**Historic District Commission  
Town Hall, Room 46  
Meeting Minutes, June 10, 2015**

**9:00 PM 525-545 Massachusetts Ave.: Review of Changes in Project and Proposed Solution**

**Attached: Drawings for discussion of 525-545 Massachusetts Ave.**

**2** Roof Edge Detail @ Middle Building Porch  
 $1\frac{1}{2}'' = 1'-0''$

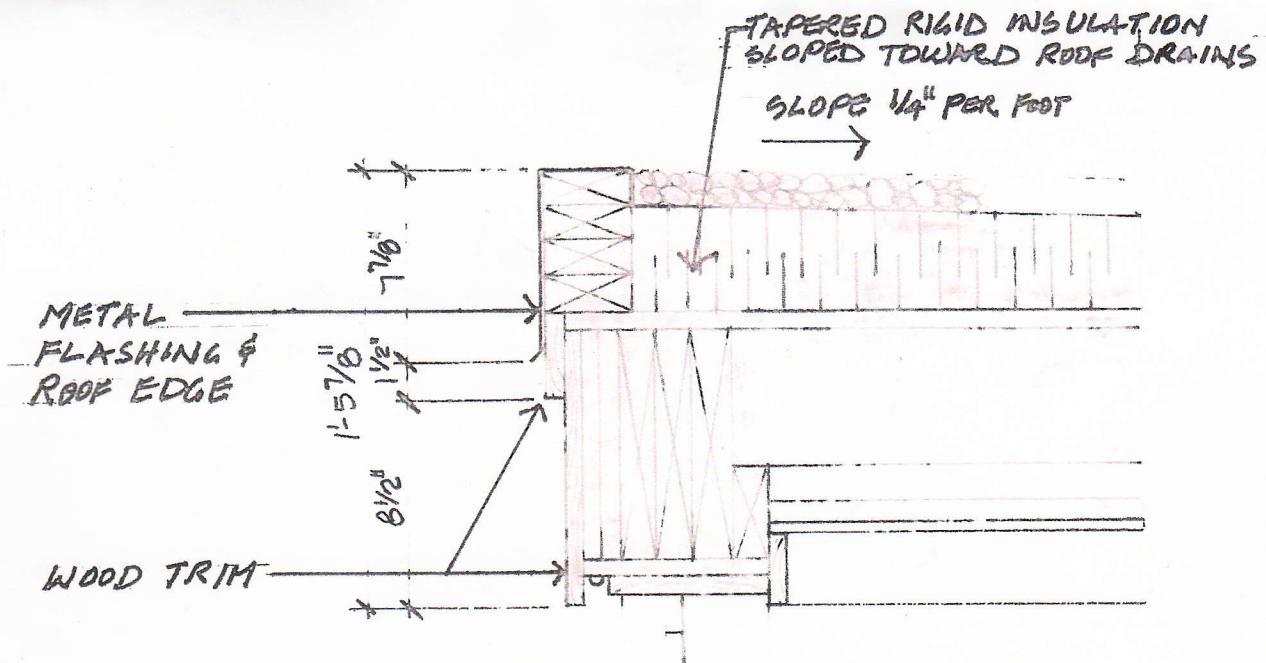
Issue 1: Middle building – eave of porch ... The built roof edge detail varies from the drawings because of the addition of (3) 2x4's needed to achieve the necessary slope for drainage. This 4 1/2 " is added to the thickness of the roof and is now concealed with a large piece of metal

flashing (6" or so) which is not acceptable in appearance. The original detail shows a nearly 14" thick roof with a wood fascia and a small metal drip edge – less than 2".

AR used three drawings of the roof edge detail of the middle building

- 1 to have been
2. how was built
3. OMR proposed remediation annotated by AR with the block solution

ROOF EDGE DETAIL @ MIDDLE BLDG PORCH - AS INSTALLED  
 $1\frac{1}{2}'' = 1'-0''$  5.15.15 OMR ARCHITECTS

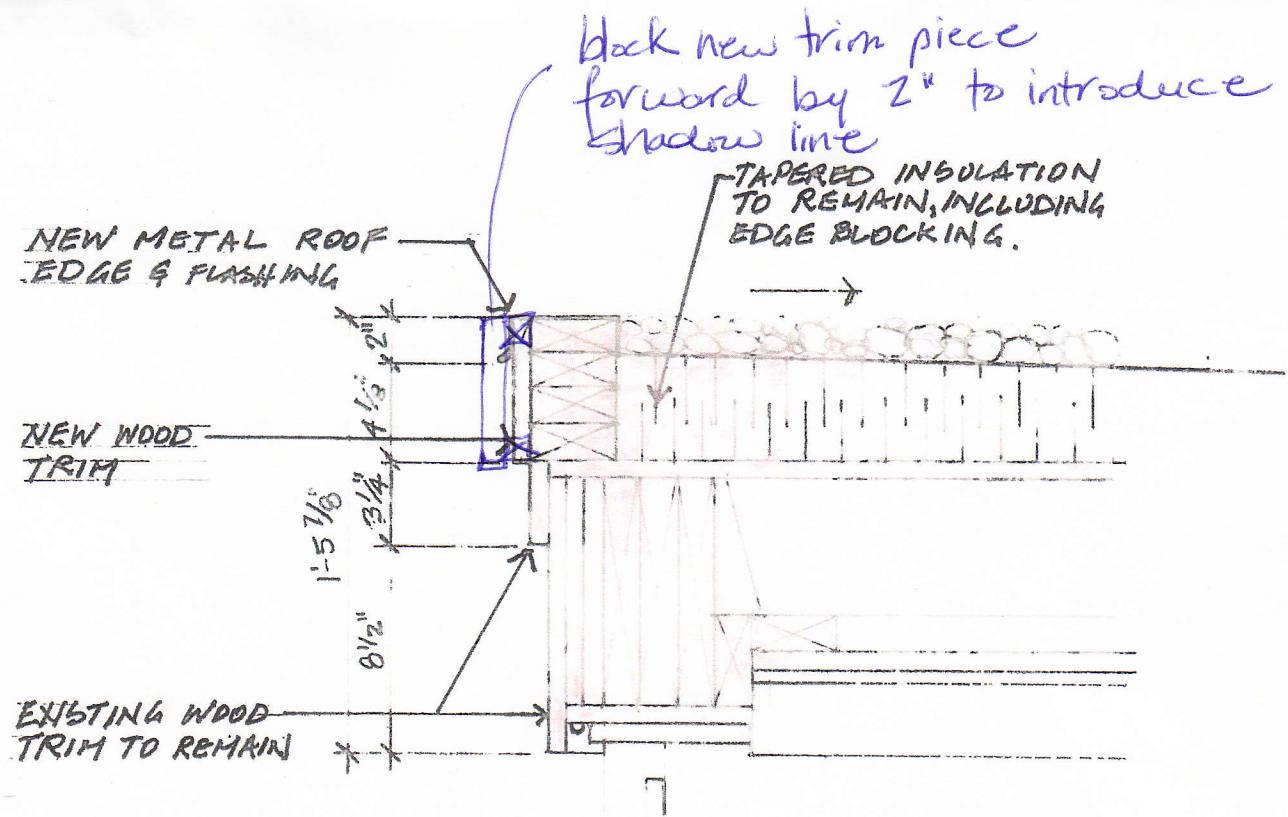
KAB commented that it currently looks like a disproportionate band of white. It looks clunky. Maybe painting a portion of it grey might diminish the visual impact. Or is there a way to build in some relief?

DH suggests blocking the fascia, the new ... forward 2 " or so, so it overhangs the new 3 1/4" trim. DH was not in favor of the profiled molding which is inconsistent with the rest of the building's trim.
